## ASSESSMENT REPORT

### THE DAN LAND MP 06\_0031 MOD 4

This report is an assessment of a request to modify the Concept Plan and Project Approval (MP 06\_0031) for a residential subdivision at 290 and 302 Minmi Road, Fletcher in the Newcastle local government area.

**Figure 2:** Approved subdivision layout (note: Stage 10 subject of this current modification application in **RED**) (Source: Proponent)

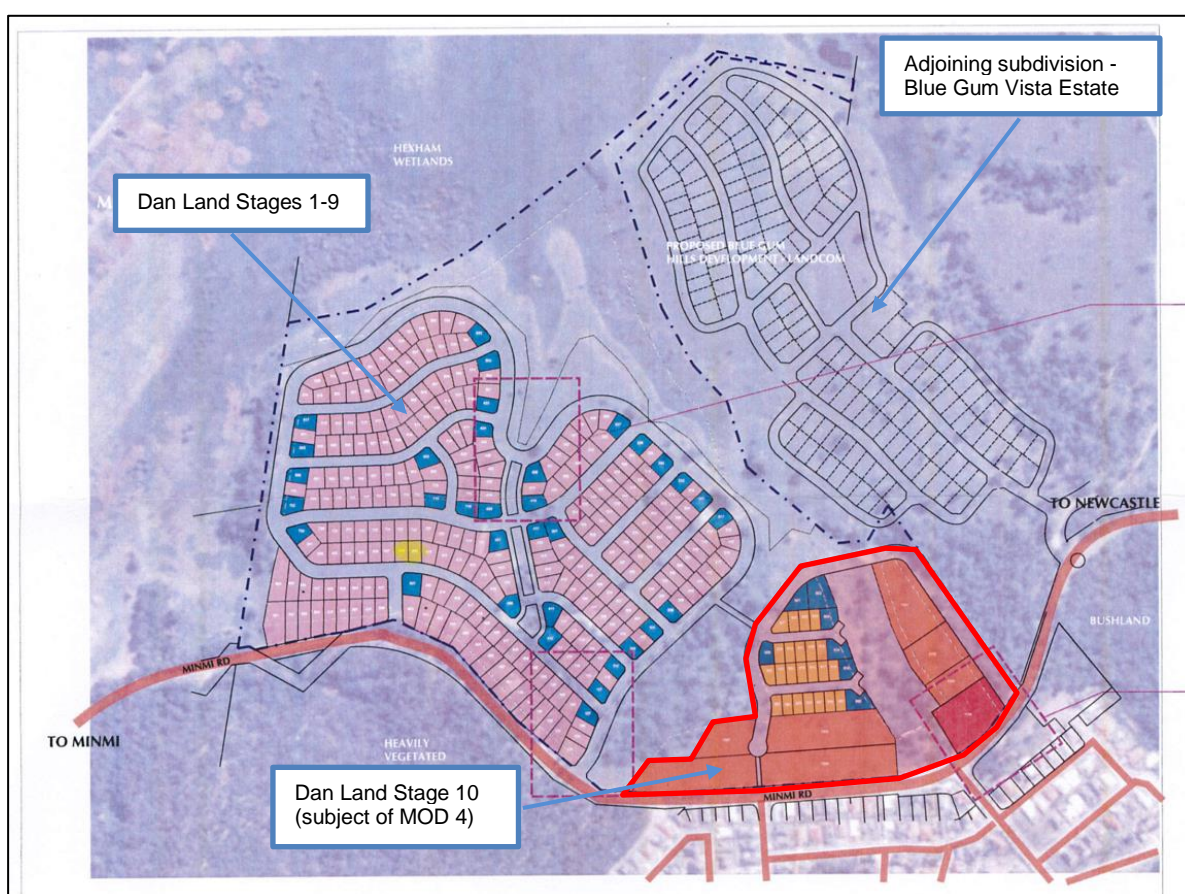
The approved subdivision layout is shown at **Figure 2** (refer **Section 3** above). The subdivision layout, as proposed to be modified, is shown at **Figure 4** (refer **Section 4** above). The Proponent considers the deletion of the approved cul-de-sacs and creation of loop roads would provide improved connections throughout the subdivision and the requirements of Condition B10 are comprehensively addressed.

As a part of its assessment of MOD 1 the Department imposed Condition B10 (b) and (c). These changes were required to ensure Stage 10 of the subdivision better connected with the development on the southern side of Minmi Road. The Department has considered the revised road network connections and access arrangements for Stage 10 and is satisfied the requirements of Condition B10 (b) and (c) are addressed as part of this modification. Further, the Department considers the proposed loop road results in improved design outcomes, rather than the creation of cul-de-sac roads.

- Condition B10 be deleted;
- new Condition B12 be inserted requiring the works associated with Minmi Road be completed prior to the release of respective Subdivision Certificates;
- new Condition B13 be inserted confirming the design and construction of the connection to the Sanctuary Estate be provided at no cost to Council; and
- new Condition B14 be inserted requiring a Restriction on the Use of Land be registered against the title for all residential lots adjacent to Minmi Road to prevent direct vehicle access (Lots 30 to 36 inclusive and Lots 101 to 114 inclusive)
- new Condition B20 be inserted which refers to Council's recommended shared path network.

**Figure 5:** Proposed Lot 114 boundary as originally proposed (left) and as amended as part of the RtS (right) (Source: Proponent)

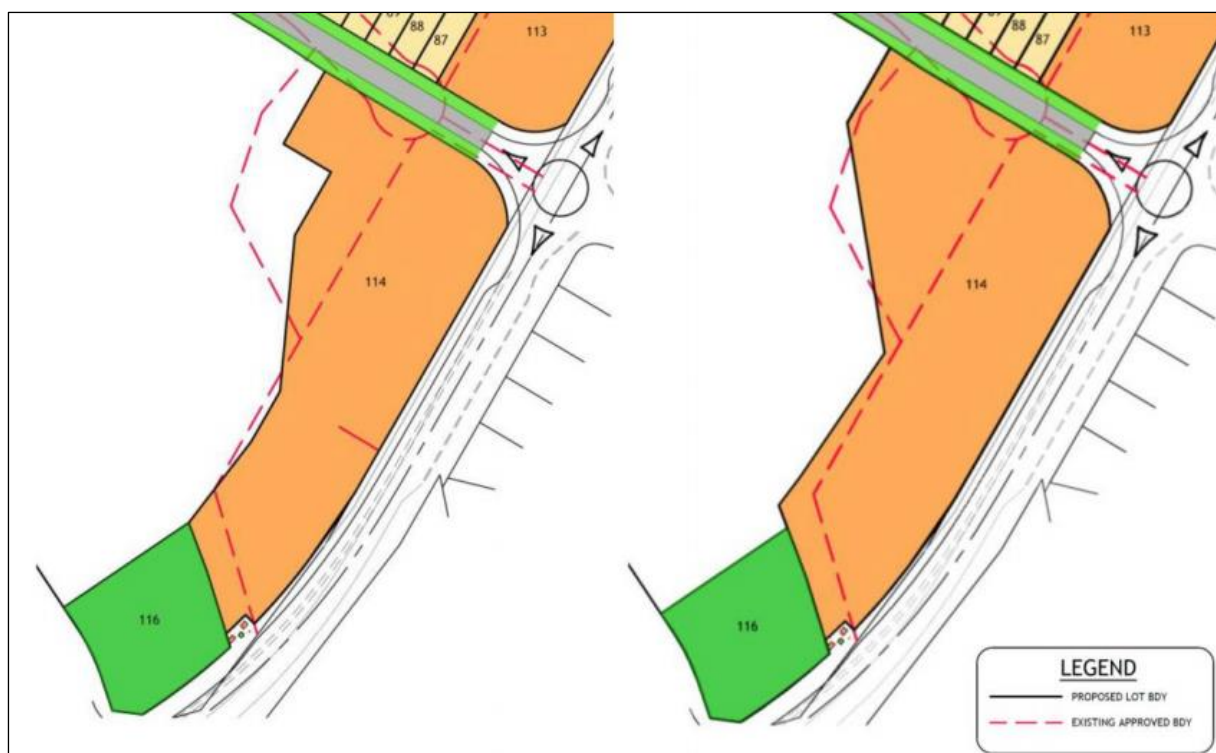
A BAR is submitted as part of the RtS to address the RFS' submission (discussed further at **Section 7.3**). As result of the recommendations provided in the BAR, the Proponent amended the northern boundary of Lot 114 to ensure an appropriate APZ is provided to the future medium density housing. The boundary of Lot 114 (as originally proposed) in comparison to the amendment made as part of the RtS is shown in **Figure 5**.
